TECHNICAL SERVICE BULLETIN

74-D-8

Austin MG

GEARBOX CENTER BEARING TO CIRCLIP END-FLOAT

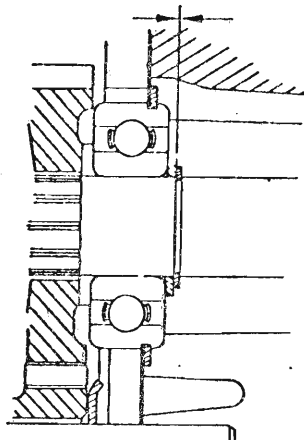
In order to facilitate adjustment of the mainshaft center bearing, the tolerance has been increased from .000/.002 to .000/.004.

The current range of selective washers remains unchanged.

Refer to Page 37-20-04 of the Workshop Manual - Part #AKD 7975.
